PRODUCT ADVISORY

**Corrections to Standard
Microcircuit Drawing
5962-95729 for Intersil
Product HCS154***

**Refer to:
PA10091**

Subject: **Corrections to Standard Microcircuit Drawing 5962-95729 for Intersil Product HCS154***

Incorrect Logic Diagram – PA10091

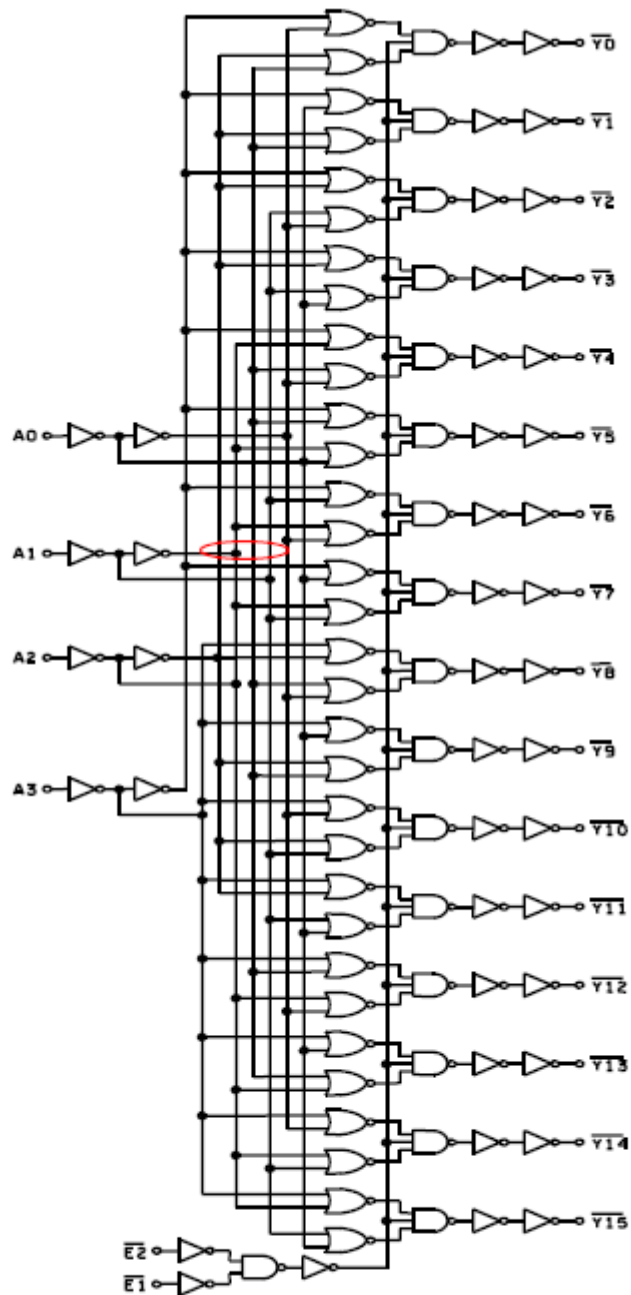
This advisory is to inform you that Intersil has made corrections to DSCC (Defense Supply Center Columbus) SMD (Standard Microcircuit Drawing) 5962-95729 for the HCS154* products. The updates correct errors in the Truth Table (Inputs A0 – A3 were reversed) and Logic Diagram (Input A1 connection). There have been no changes of any type to the screening or product itself. The updates to the DSCC SMD are complete. The released SMD is available on the DSCC website at <http://www.dsccl.mil/downloads/milspec/smd/95729.pdf>.
